Thrumster Wastewater Scheme Objection

Figure 2-1 Daily rainfall for the Fernbank catchment (2015-16)

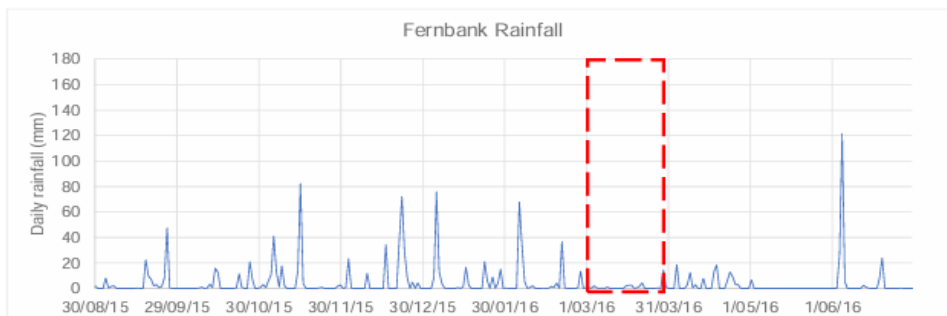
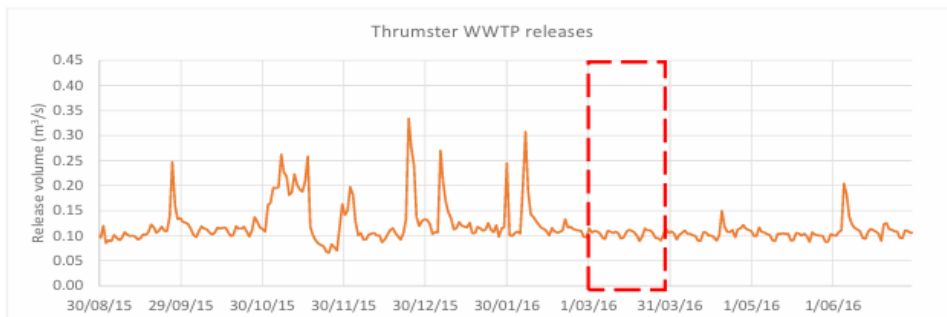
This analysis appears to rely on outdated data, using a dry-month scenario from records that are approximately nine years old I believe this is the best case scenario and modelling should have been based on worst case scenario with heavy rain periods to predict real water quality impact to the environment. More comprehensive modelling that considers recent climate trends and wet-weather events should be undertaken to ensure environmental integrity.

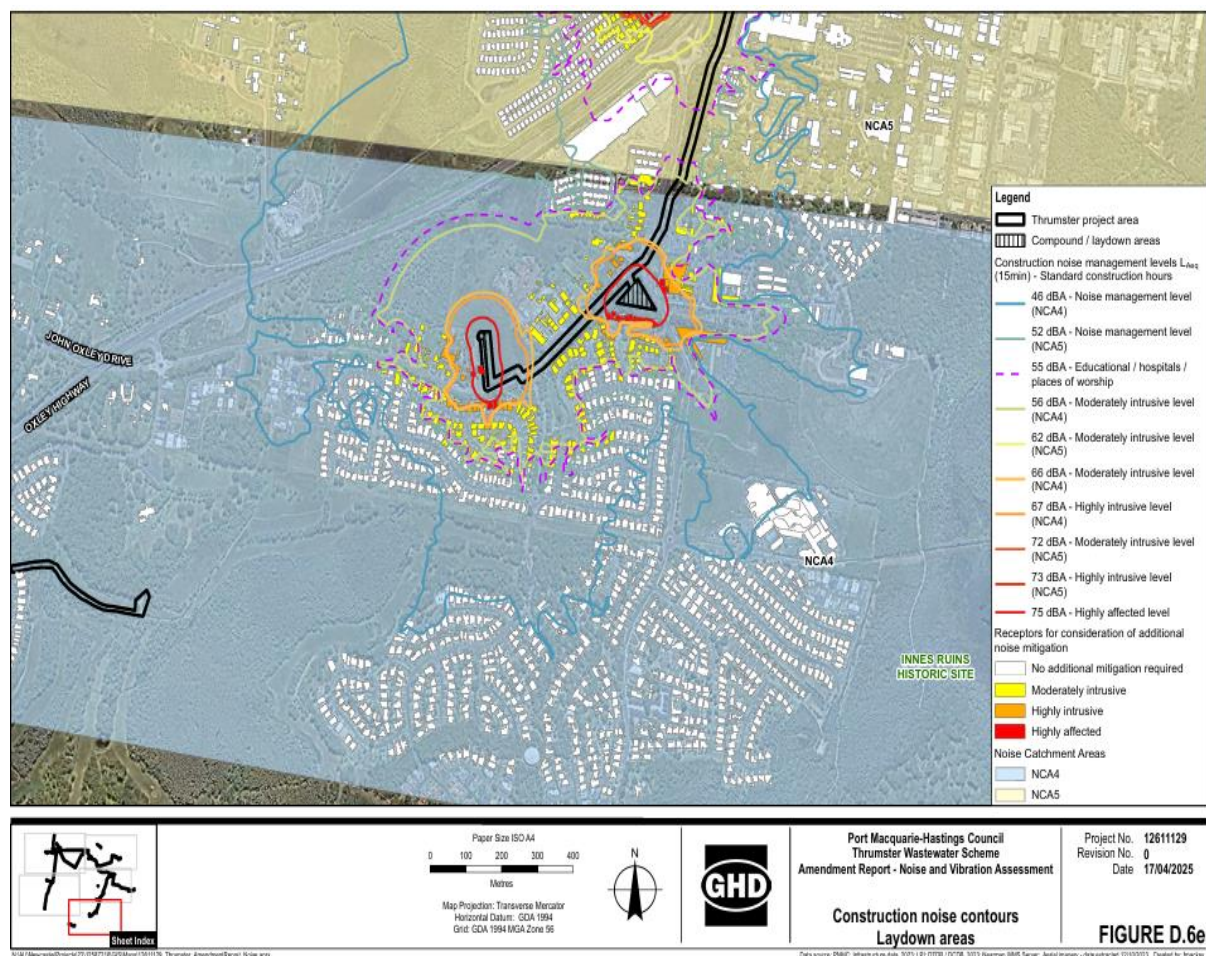
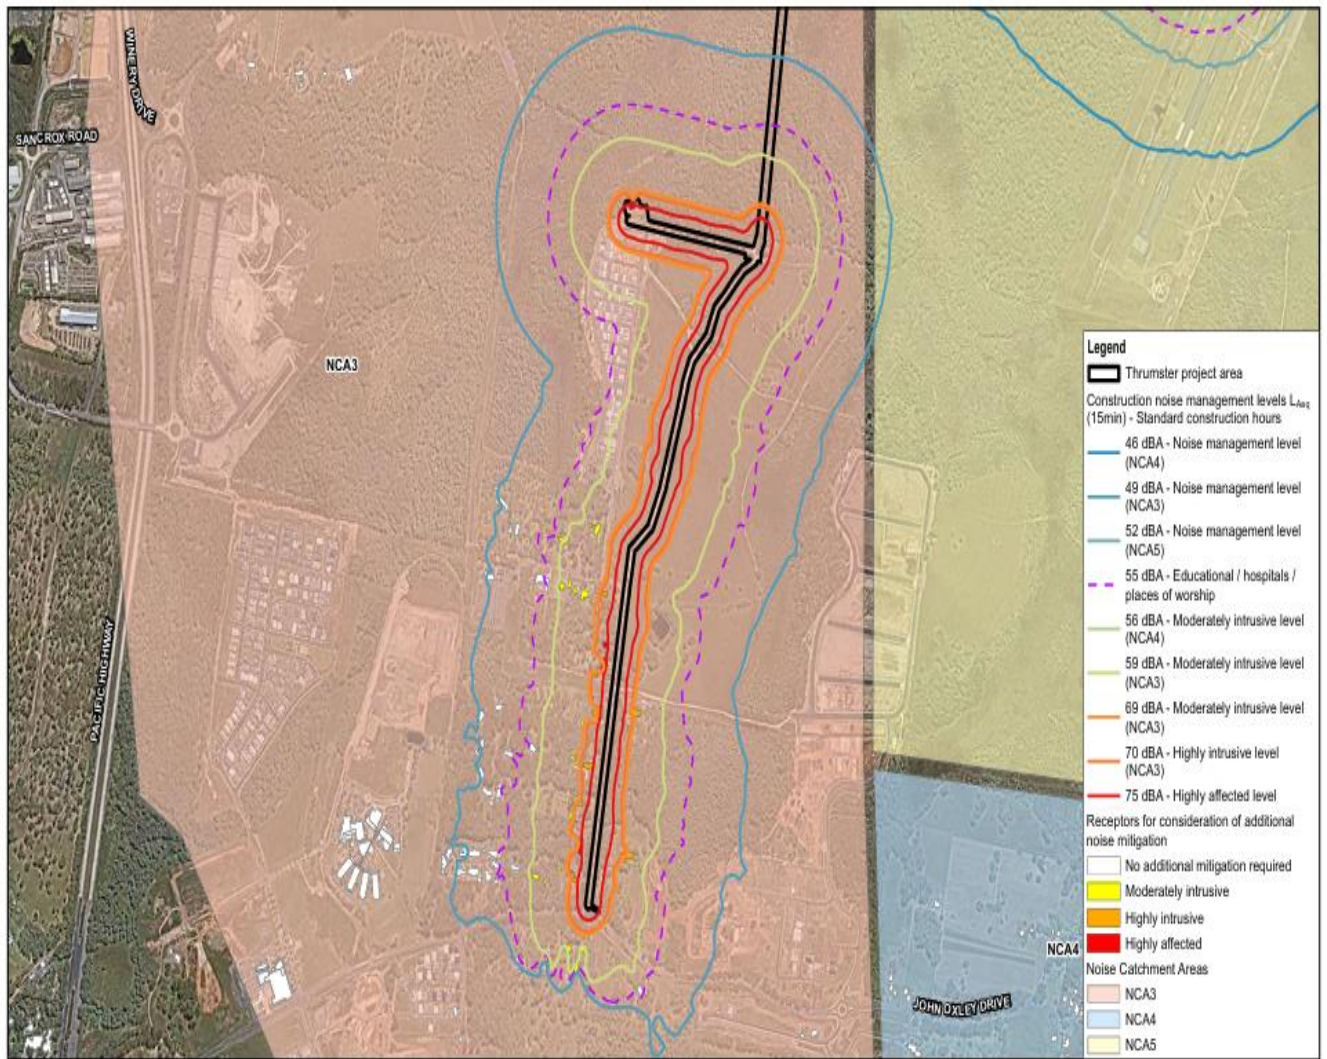
Appendix F of the Amended Report of Thrumster Wastewater Scheme contains critical data on highly impacted properties yet it appears placed at the very end from page 1399 to 1412, perhaps in the hope it would be overlooked by the uninformed impacted properties.

The maps provided in Appendix F maps (see below) are difficult to decipher due to omitted road names, making it unclear which properties will be affected. Improving transparency and accessibility of this information is essential to ensure impacted residents can properly assess the risks.

FIGURE D.4d

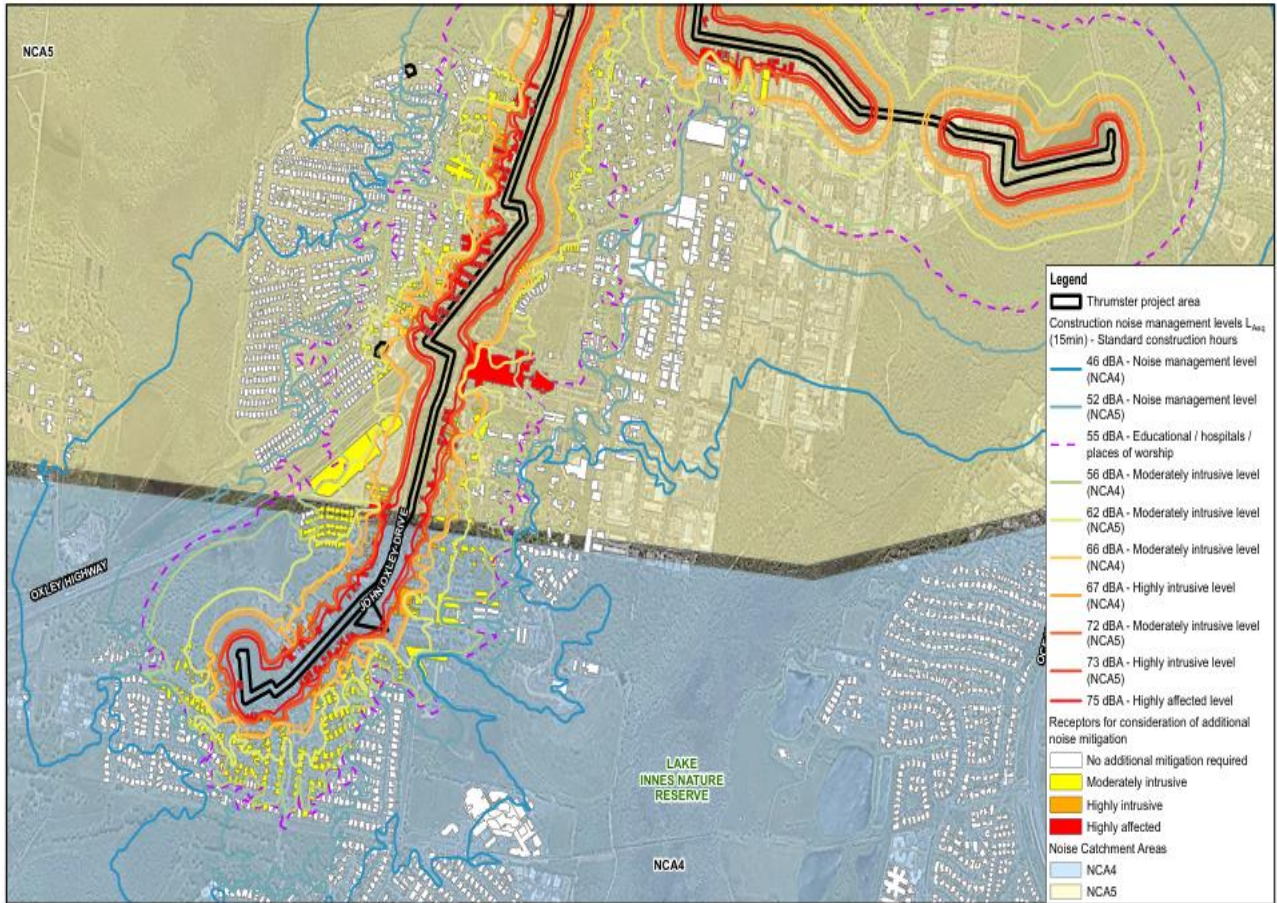
Neighbouring residents still lack precise information of intensity, hours, days, weeks and months that vibration will be affecting them from drilling, and delivery of land fill during construction. We still have not been informed!
